# COMMISSIONING REPORT

■■■■■ Building

The [REDACTED] Building underwent an HVAC replacement project [REDACTED] in 2021-2022 which consisted of the demolition and replacement of the HVAC equipment and systems within the building to improve occupant comfort.

Since this HVAC replacement project has been completed there have been ongoing issues with system performance and occupant comfort. The [REDACTED] contacted us in early 2024 to inquire about performing a retro-commissioning process on the HVAC equipment and systems within the facility as well as performing a review and study of the original design documents from the 2021 HVAC replacement project. Contained within this report are the results of our on-site testing and design review.

Figure 1: There is an additional unknown thermostat located in room 014. The thermostat for UH-3 was found to be located as shown by the arrow.

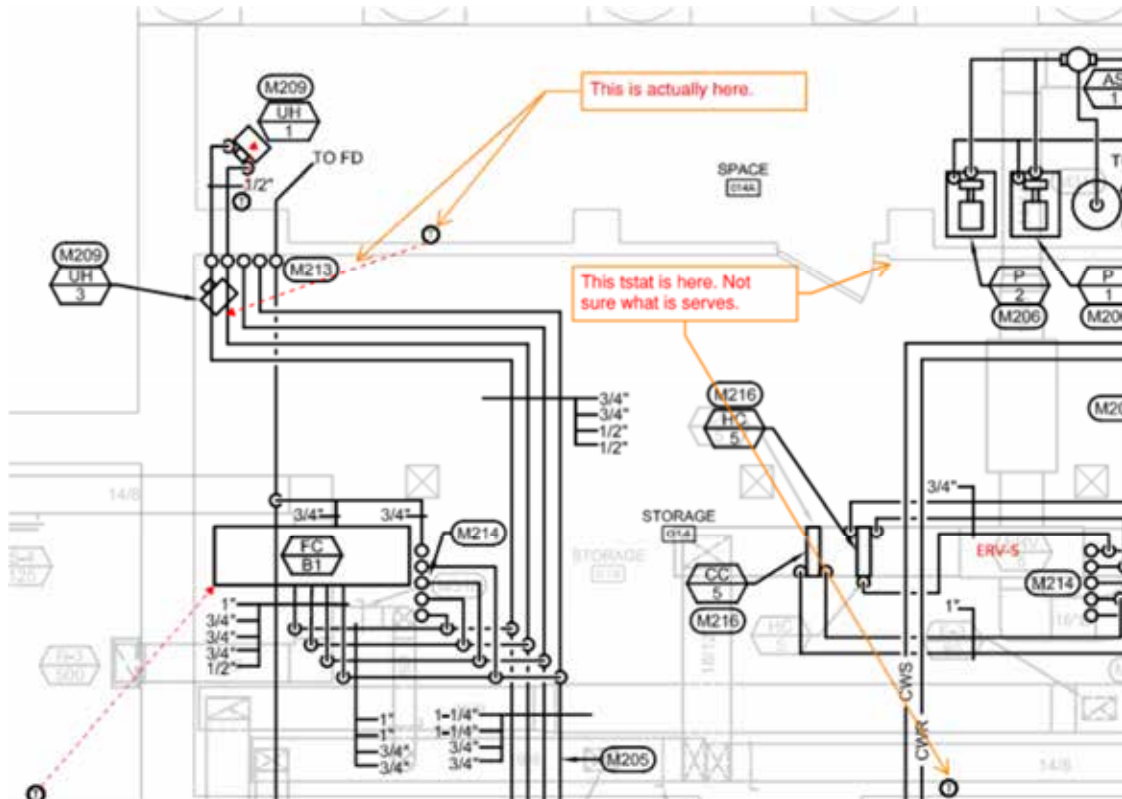
- Thermostat in Room 104 does not control anything as far as we can tell.
- Thermostat for Unit Heater 3 is on the other side of the wall from where it was indicated in the drawings.
- CFC-B5 and CFC-B9 are linked and controlled by the same thermostat.
- CFC-B8 and CFC-B3 are linked and controlled by the same thermostat.

We recommend that the unit heater and finned tube radiation units be fully incorporated into the BAS graphics as they were called out in the approved shop drawings. The UH thermostat twinning that was noted above should also be corrected.

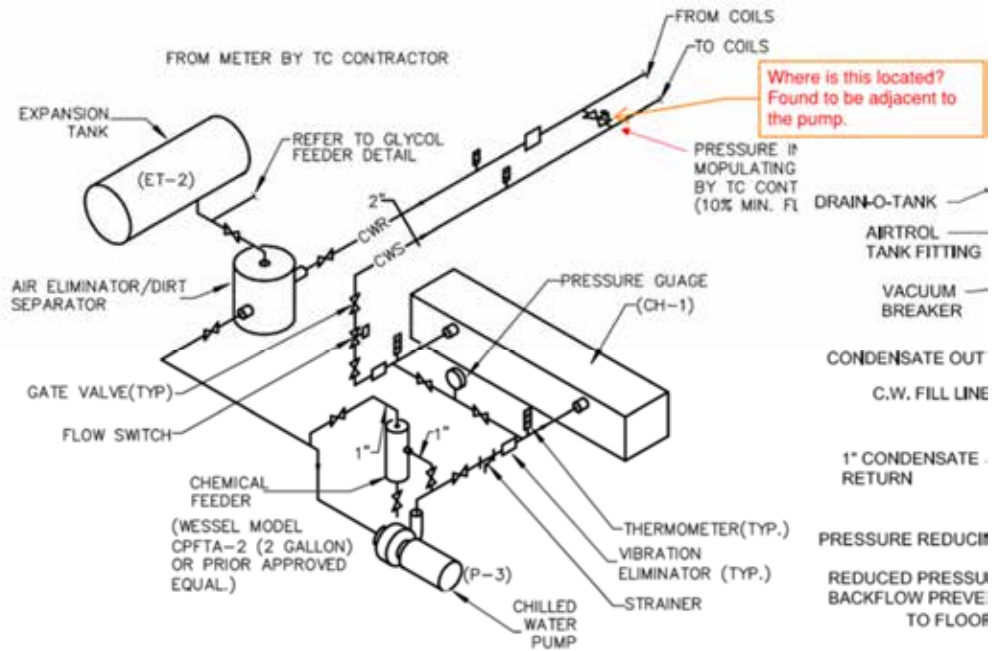
Design chilled water flow and pump sizing do not match. According to the record drawings, the air-cooled chiller was sized with a 55 gpm maximum flow and a 15 gpm minimum flow requirement. The single, primary chilled water pump is sized at 40 gpm with a 65 ft/hd. In reviewing the chiller design submittals, a 55 gpm flow rate was indicated. What we found however, is that all the design chilled water flows add up to 29.8 gpm which is 54% of the design chiller flow and also short of the chilled water pump design sizing criteria. The balanced flow for the chilled water pump was indicated as 29 gpm at 73.9 ft/hd. The chiller will not be able to achieve full design performance without the design water flows. ***This is possibly a large contributor to the building issues, specifically the building overheating. Additionally, the chiller will have a shorter life-span due to excessive cycling.***

- Design chilled water pump = 40 gpm @ 65 ft/hd.
- Balanced chilled water pump = 29 gpm @ 73.9 ft/hd.

- Design chiller full load flow = 55 gpm
- Balanced chiller flow = 29 gpm with pump triple duty balancing valve 100% open
- Design total chilled water flow = 29.8 gpm
- Balanced total chilled water flow = 32.0 gpm

③ CHILLED WATER PIPING SCHEMATIC  
NO SCALE

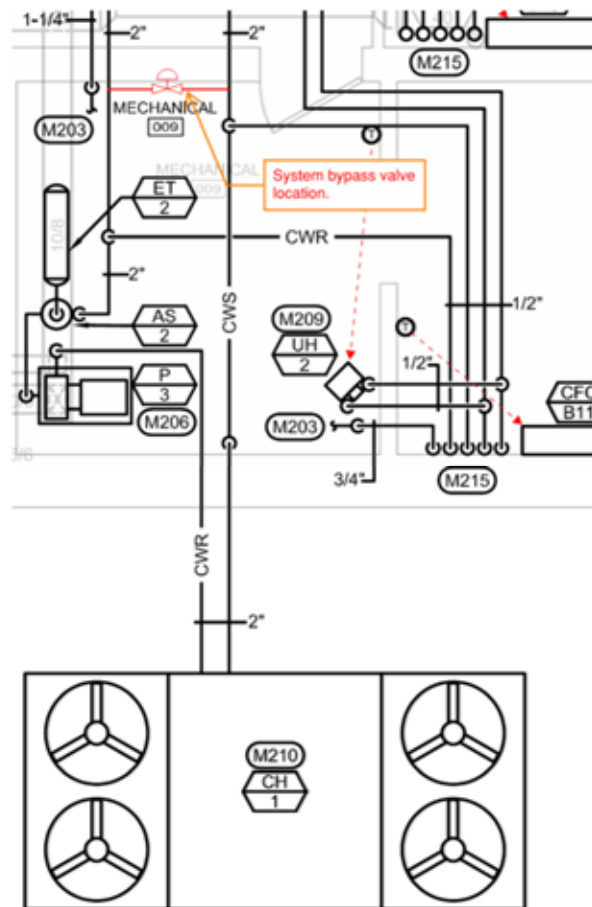
The chilled water system volume was also an item of question while performing the design analysis. The design vs. installed conditions for the chiller, pump, and devices aren't coordinated. Part of this relates to the installation details for the chilled water system (detail 3/M501) which shows a 2-way bypass valve for providing minimum flow control for the chiller as all devices are 2-way control valves. Neither the detail, nor the drawings indicate where this 2-way bypass valve should be located. We found on-site that this bypass valve was installed in the same room as the chilled water pump. ***This location of this bypass valve is likely a large contributor to the building issues, specifically the building overheating. (See below.)***

Ideally a system bypass valve for minimum flow is installed closer to the end of the run on the chilled water loop.

Since this system bypass is located in close proximity to the chiller and pump, we believe that this is contributing to a situation where the chiller is not experiencing enough system volume to allow for stable chiller operation. According to the chiller IOM information, the chiller should have a 2-minute minimum on-time to maintain the proper oil level, the compressors must cycle on for a minimum of 2 minutes. This 2-minute minimum runtime is not possible with the volume of the chilled water system as-designed, installed, and controlled currently. This is especially evident during periods of lower system demand - when most of the building cooling control valves are closed.

Another issue with the chilled water bypass leg is that it is not meeting its purpose of providing minimum flow protection for the chiller. The chiller is rated to have a minimum flow rate of 15.3 gpm at minimum load and 55 gpm at full load. Currently [REDACTED] is controlling the minimum flow bypass valve to maintain a 30 gpm flow at all times. This is incorrect and results in the valve being 70-80% open most of the time. Since this valve is open and bypassing 30 gpm at all times, this contributes to the chiller not being able to maintain minimum run times. ***This is likely a large contributor to building issues, specifically the building overheating.***

3. Chilled water loop bypass valve operation needs to be corrected. This bypass valve should be programmed to ensure that flow through the chilled is never less than 15.3 gpm. This valve should be closed unless flow through the chiller drops below 15.3 gpm. As it is currently being controlled, chilled water is continually being short-circuited through the system and back to the chiller.
